Frication Angle and Stability of Slopes (T Cao, 6/8/2014)

This write up addresses friction angle and slope stability issue raised by NRC staff in SER section 2.1.1.1.3.5.4 (Site Geotechnical Conditions and Stability of Subsurface Materials).

Figure 1.1-80. Conditioned and Unconditioned Reference Rock Outcrop Mean Horizontal Peak Ground Acceleration Hazard Curves (From SAR)

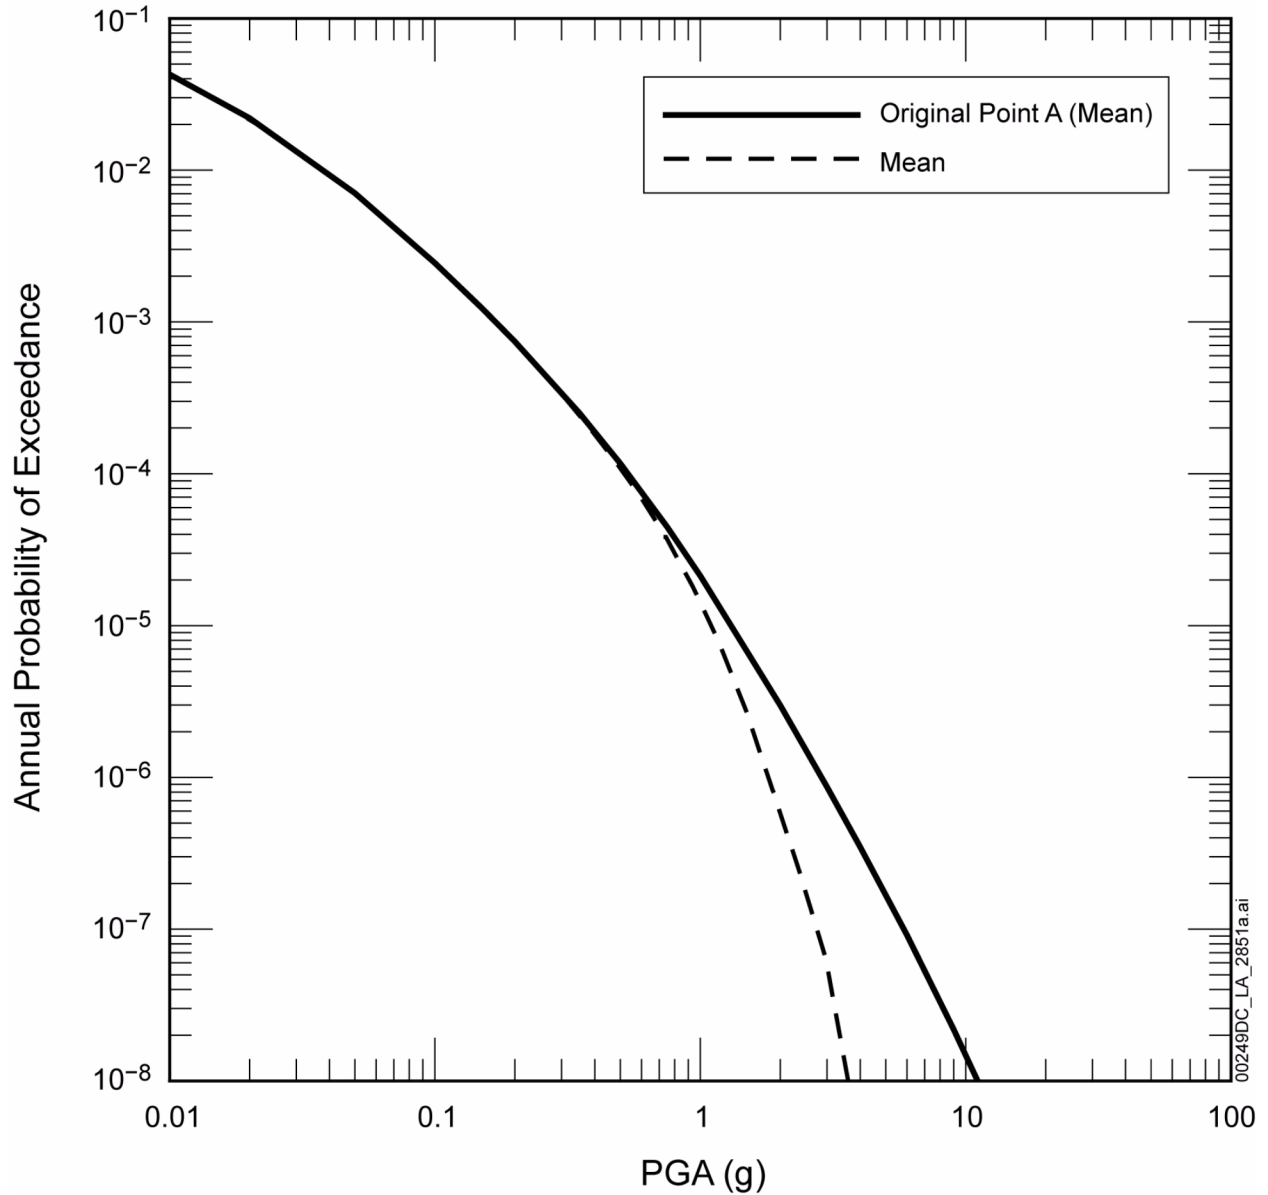
It seems obvious that safety factor is too low when the friction angle is at 33° and the staff's concern is valid. But let us do another analysis, which DOE and NRC staff didn't realized its advantage.

As shown in BSC (2002ab) Table 1-11 (Summary of and Statistics for Relative Density Results), the friction angle has a large uncertainty and follows a distribution with mean=68, median=71, stand deviation=21, maximum =120, and minimum=25. So we can get the cumulative density function (CDF) of this distribution and find that the probabilities for friction angle less and equal to 39° and less and equal to 33° are about 0.07 and 0.04 respectively. The probability for the DBGM-2 horizontal peak ground acceleration of 0.45 g is 10^{-4} (see attached SAR Fig. 1.1-80). The weighting factor (0.1 to 0.5) used above to get the low FS for dynamic slope stability is 0.5. If 0.3 is used, the dynamic slope FS will be 1.0. So from 0.1 to 0.5, only 1/3 of the chance the FS will be smaller than 1.0. We can include this factor into the calculation of the final probability for FS less than 1.0 when friction angle 33° is used, which is $0.04 \cdot (1/3) \cdot 10^{-4} = 1.3e-6$. This is too low to be considered as category 2 events. For friction angle of 39° the probability is $2.3e-6$, also showing not Category 2 events. We can find a higher PGA probability to make up the event probability qualifying for being Category 2 event. This PGA probability will be $7.5e-3 (=10^{-4}/(0.04 \cdot 1/3))$. But for such high probability, the PGA is only about 0.05 g, which will lead to safety factor nine ($=0.45/0.05$) times of 0.6, or 5.4. It is very safe.

Because the events of slope stability under seismic shaking has probability much lower than Category 2 criterion ($>10^{-4}$) when the friction angle is as low as 33° , there is no need to be considered.
